PLANNING AND ZONING CASE CHECKLIST

Project Number: SP2019-024
Project Name: Friendship Baptist Church
Project Type: SITE PLAN
Applicant Name: [APPLICANT]
Owner Name: ATHEY, BOBBY FRANK
Project Description:

Type of Review / Notes	Contact	Sent	Due	Received	Elapsed Status	Remarks
SP2019-024 Site Plan for Friendship Baptist Church: Please address the following comments (M= Mandatory Comments; I = Informational Comments)

TO: Planning and Zoning Commission
DATE: August 13, 2019
APPLICANT: Shannon Thomas; *Friendship Baptist Church*
CASE NUMBER: SP2019-024; *Site Plan for House of Worship*

A LANDSCAPE PLAN

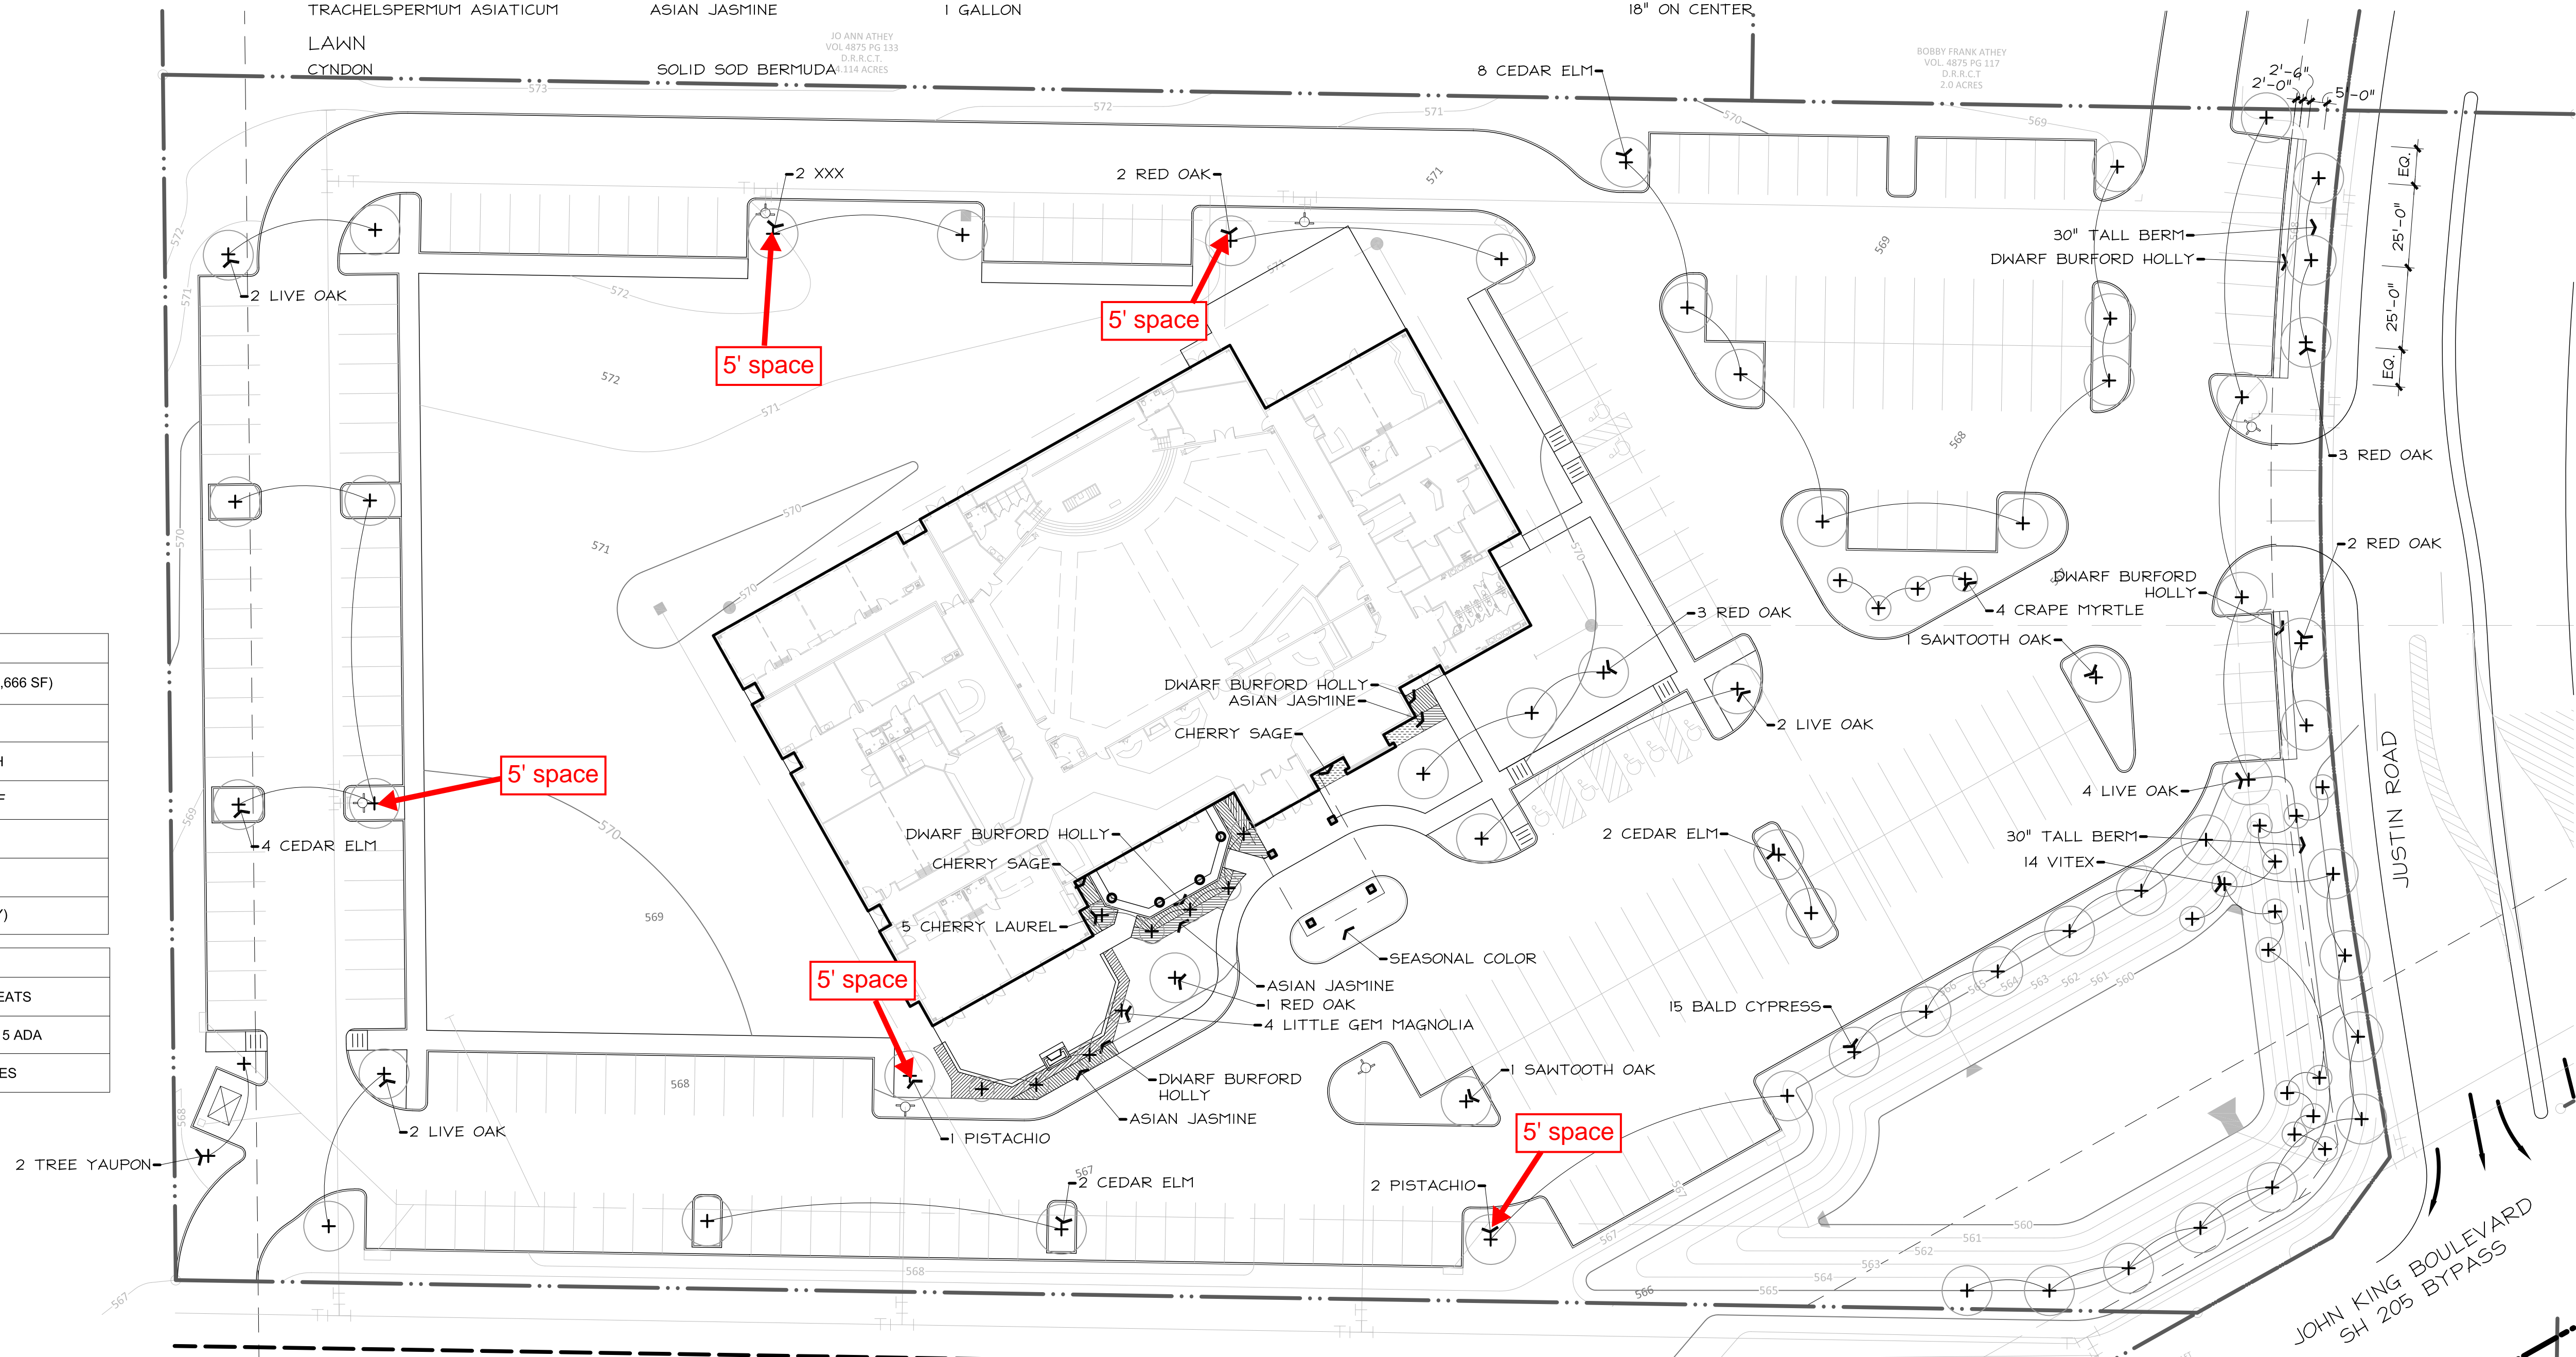
16.						Site Plan—Please dimension all walls (e.g. the recesses on the west side of the building are not dimensioned).
17.						Landscape Plan—Please label the property line

18.						Landscape Plan—Please show and label the landscape buffers
19.						Landscape Plan—Please show grass/groundcover as a stipple hatch pattern.
20.						Landscape Plan—Please indicate all sidewalks

21.						Landscape Plan—Please note, the dumpster cannot face the street.
22.						Please Provide a photometric plan.
23.						Building Elevations—Please note, the John King Overlay requires 4-sided architecture. The rear of the building will have to have a parapet.

SITE PLAN
6.03 ACRES

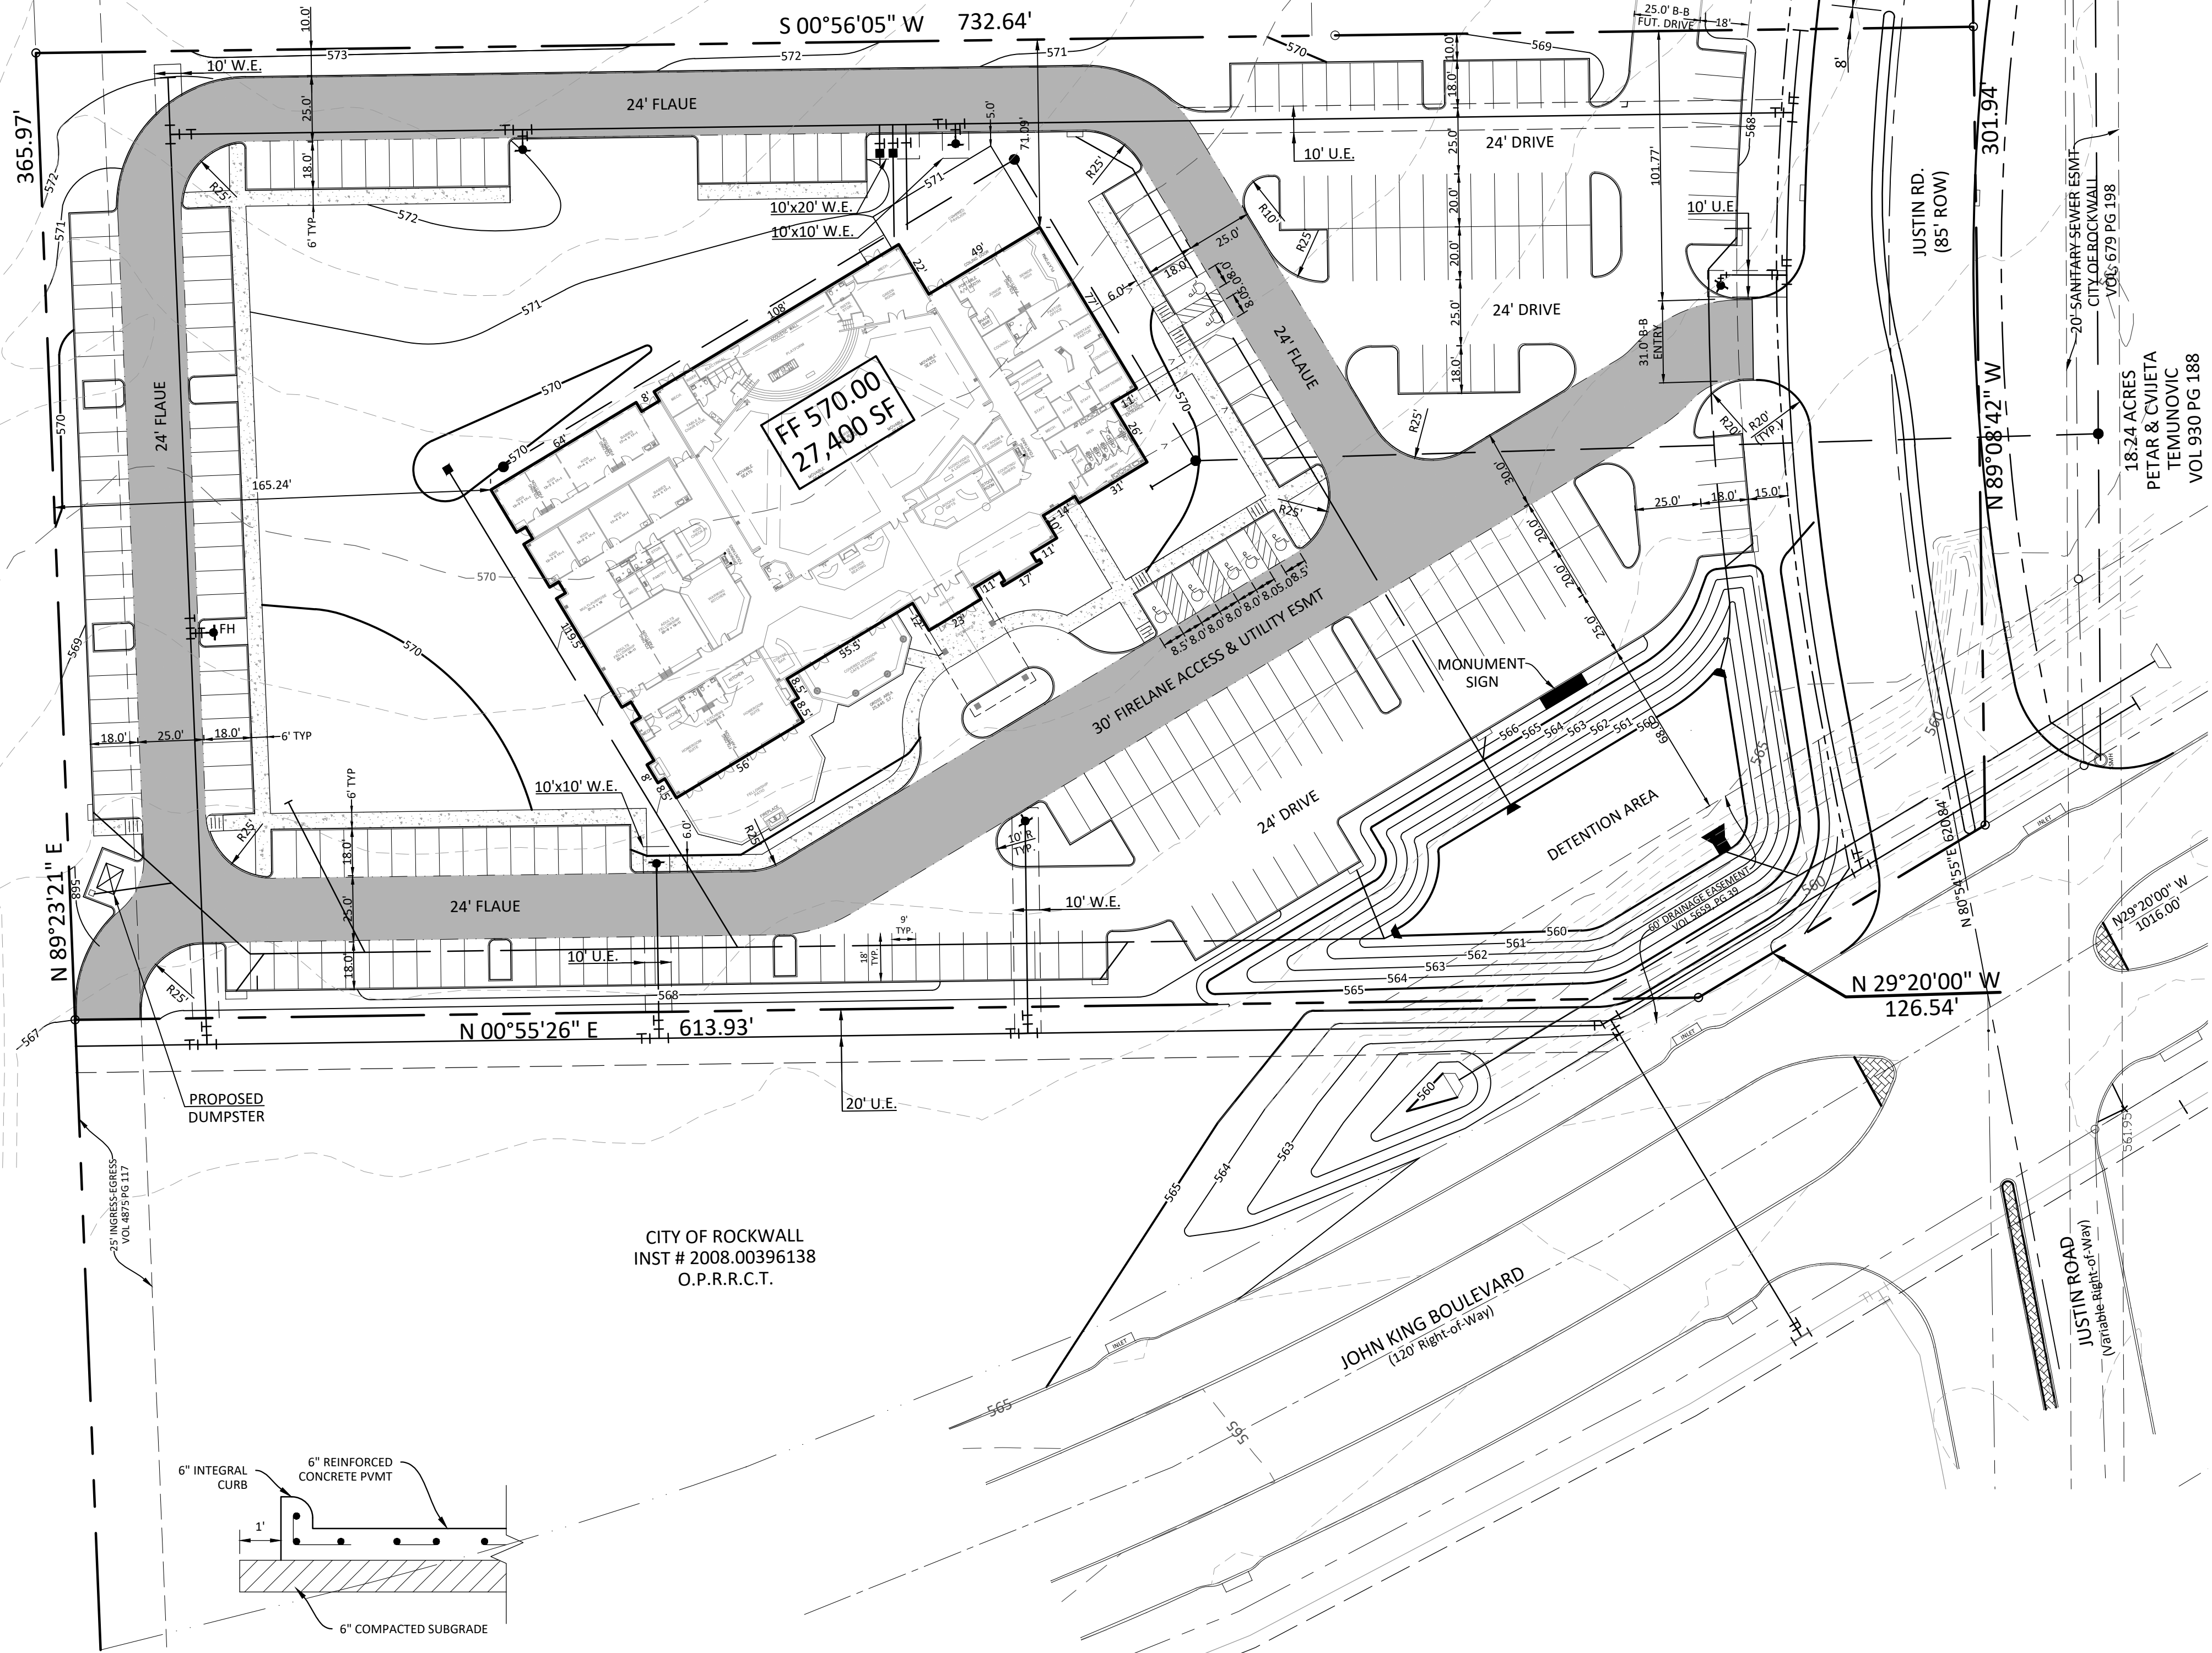
3.						For reference, include the case number (SP2019-024) in the lower right hand corner of all pages on future submittals.
4.						Site Plan—Please show and label the landscape buffers along John King and Justin Road.

5.						Site Plan—Please note, the landscape buffer is 25-feet.
6.						Site Plan—Please provide radii
7.						Site Plan—Please provide a separate floorplan at a larger size and remove it from other plans. It is difficult to read the floorplan on the site plan.

8.						Site Plan—Please breakdown each use (e.g. office, classroom, etc.)
9.						Site Plan—Please remove monument sign—That is taken care of with a separate process.

10.						Site Plan—Although there are labels within the building and close surrounding areas, it is not legible.
11.						Site Plan—Please show grass as a stipple hatch pattern to differentiate from concrete.

12.						Site Plan—For clarity, please show the property line as a solid, bold line and label.
13.						Site Plan—It appears that some of your 18-foot parking spaces will need to be 20-feet—Please see engineering comments.

14.						Site Plan—Please label all utilities and sidewalks.
15.						Site Plan—Please show and label required sidewalk adjacent to John King Blvd. and Justin Rd.
